# SERVICE BULLETIN

Classification: MT97-002a	Reference: NTB97-009a	Date: June 15, 1998
------------------------------	--------------------------	------------------------

## FS5R30A TRANSMISSION WHINE

This amended version of NTB97-009 updates the Parts Information and the Claims Information.  
Please discard all paper copies of NTB97-009.

Figure 1

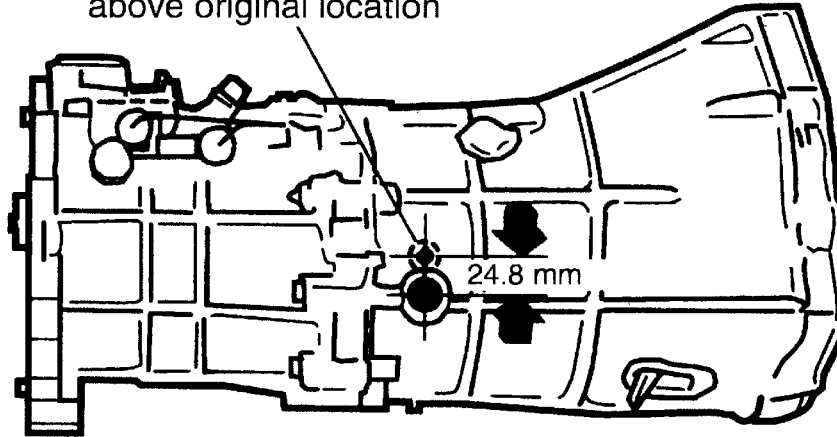
1. Verify the incident occurs under the driving conditions described above.
2. If the noise is verified, disassemble the transmission.
3. Replace the counter and main gears with new parts. Refer to the parts catalog.
4. Install a countermeasure transmission case, P/N 32101-01G11 (former P/N 32101-01G10). When installing the transmission case, note the following changes to the transmission case and fluid levels:
  - The transmission oil level has been increased from  $3.6 \pm 0.1$  L to  $5.1 \pm 0.1$  L (an increase of 1.5 L) to prevent lack of lubrication.
  - The oil filler plug has been relocated to compensate for the oil level increase (refer to Figure 1 on page 2 of this bulletin).
  - The oil filler boss shape has been changed.

Oil filler plug relocated 24.8 mm (0.97 in.)  
above original location
